## Proposal for Constellation Re-arrangement in IR HARQ

IEEE C802.16m-08/1333r1

2008-11-11

# Problem of Current Co-Re Operation

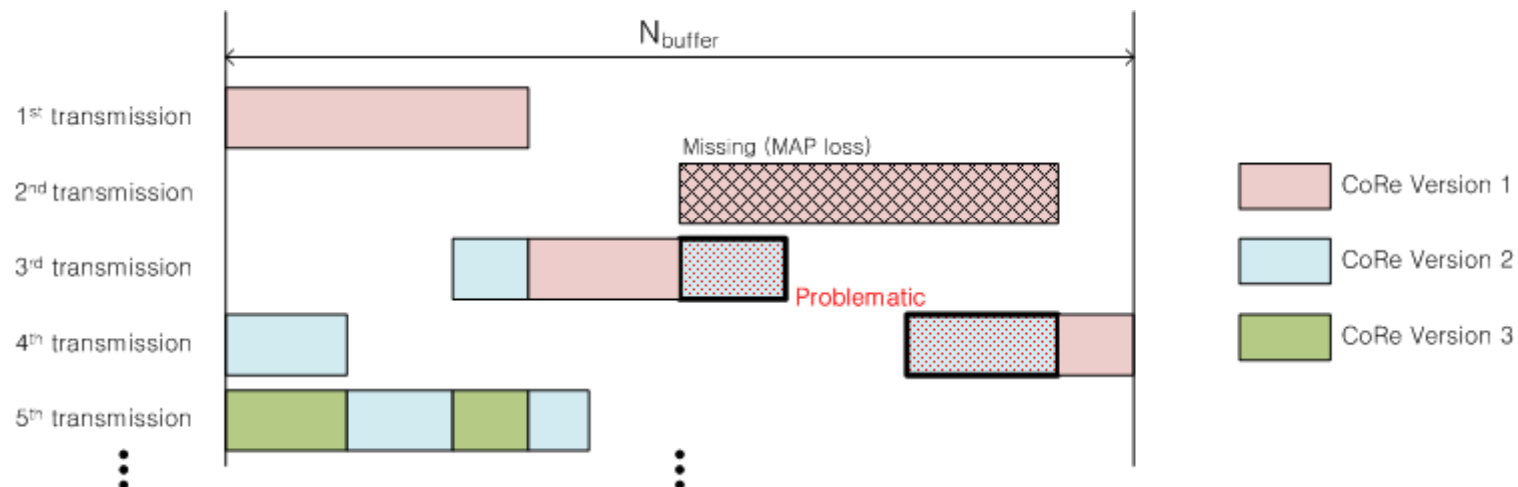
- Current Co-Re operation has a problem in case of IR-HARQ and adaptive HARQ.
  - If the MAP is missing, the MS can't know the CoRe-version for each transmitted bit.
  - In IR and adaptive HARQ operation, this problem is critical.
  - For each transmitted bit, the CoRe-version may be indicated, but the overhead is large.

# Proposed Co-Re Operation

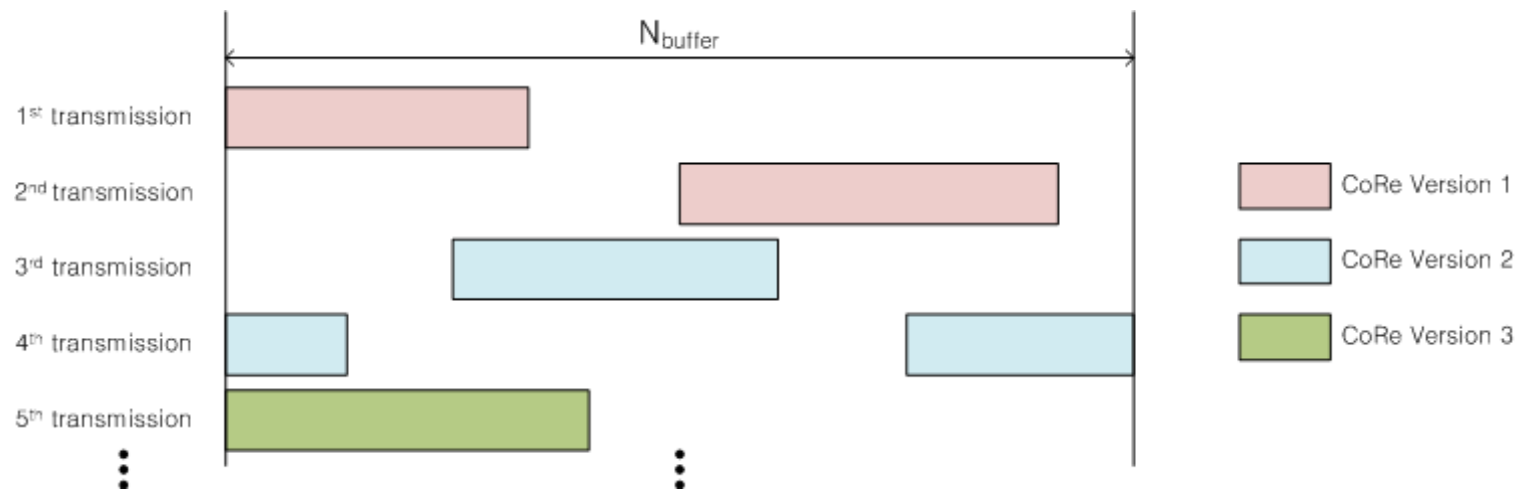
- In the proposed scheme, all the modulated symbols in a HARQ re-transmission use same CoRe-version.
  - Robust Co-Re operation in case of MAP loss
  - No additional overhead for CoRe operation

Constellation re-arrangement (Co-Re) is supported in 802.16m. ~~For each transmitted bit, the CoRe version is selected by the transmission number of this bit.~~ All the QAM symbols in the same HARQ re-transmission use same Co-Re version.  
The specific selection mechanism is FFS.
